STAFF ANALYSIS

Case No.: CZ-22-1245934 **Agenda #:** D3

Request: To modify zoning conditions to remove condition #1 pursuant to CZ-06-1241 restricting the use of the property to office and retail uses to allow a drive-through car wash in the C-1 (Local Commercial) zoning district.

DRAWING TITLES	
SITE PLAN	
PROJECT NAME:	MODWASH 1849 LAWRENCEVILLE HWY, DECATUR, GEORGIA
CLIENT:	HUTTON 738 CHERRY STREET, CHATTANOOGA, TENNESSEE 37402

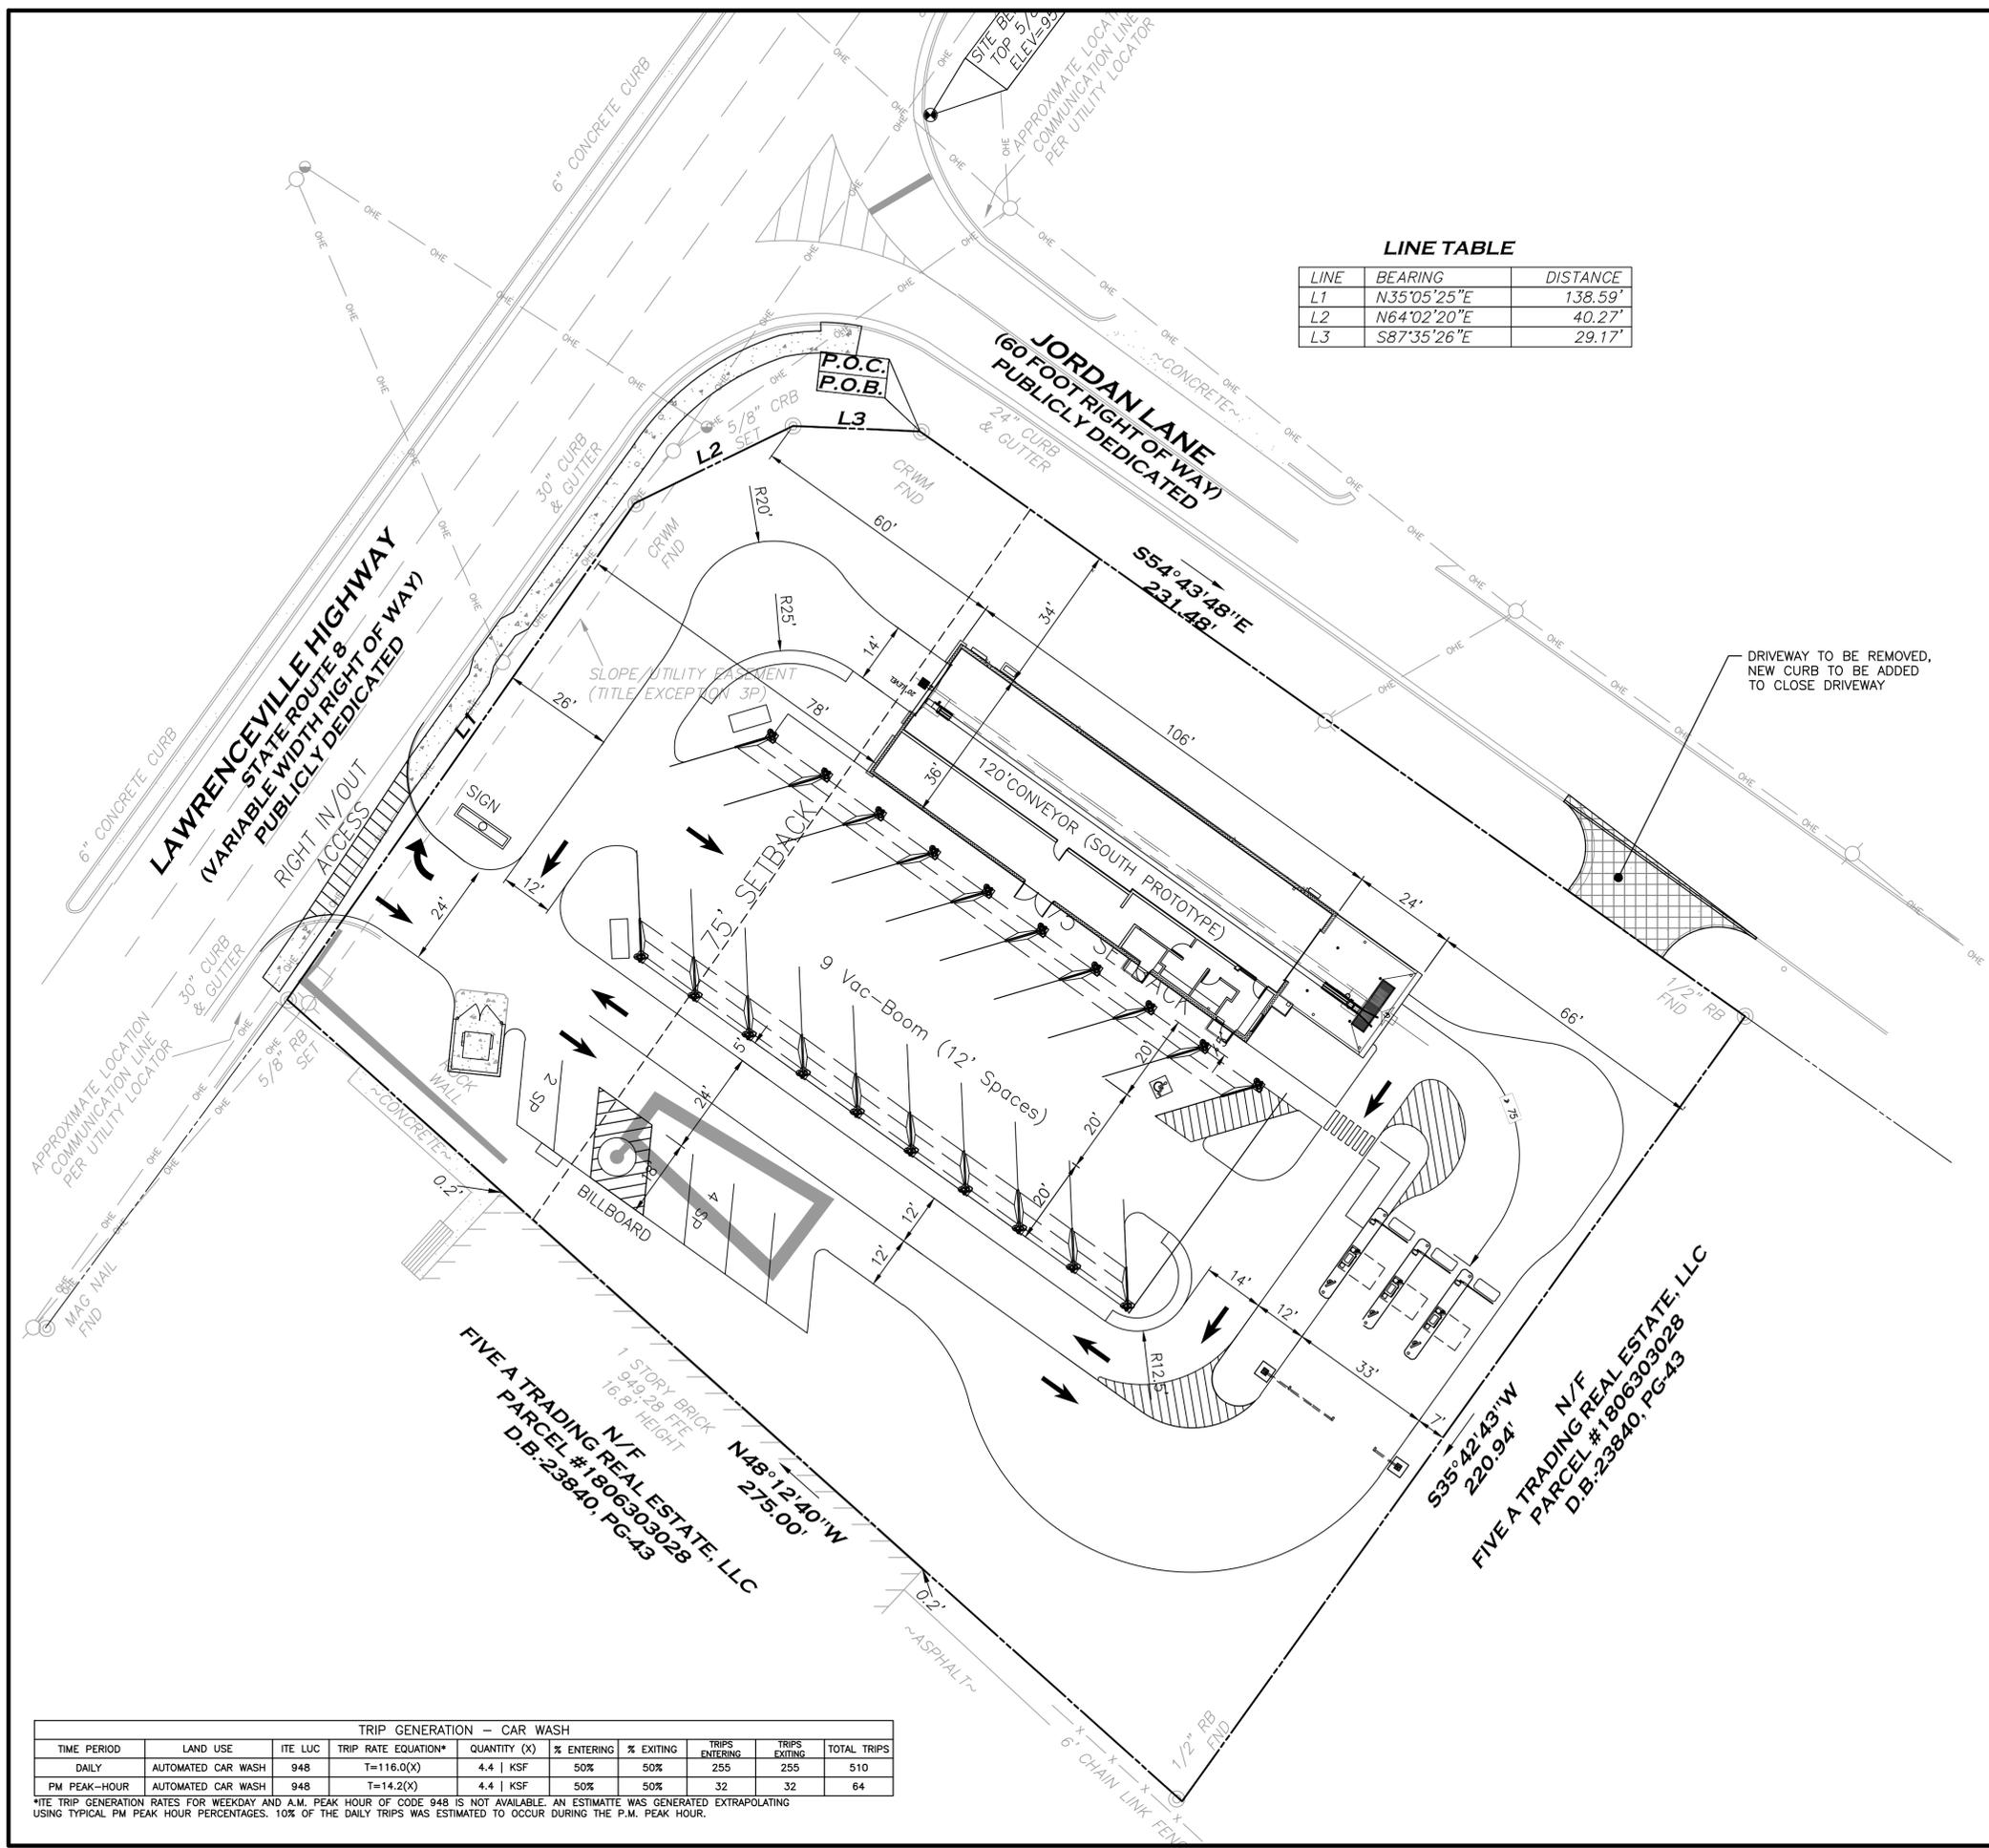
Conceptual plan doesn't indicate the location of the stormwater management facility. Location of stormwater management shall be shown or compliance with the County stormwater management regulations shall be explained.

Additional consideration must be given to the 10% downstream analysis.

Runoff Reduction Volume shall be provided, unless technical justification is provided in regard to the unfeasibility. Strongly recommend investigating the site and identify location where RRv can be provided and re-design/revise the layout to comply with the RRv requirement.
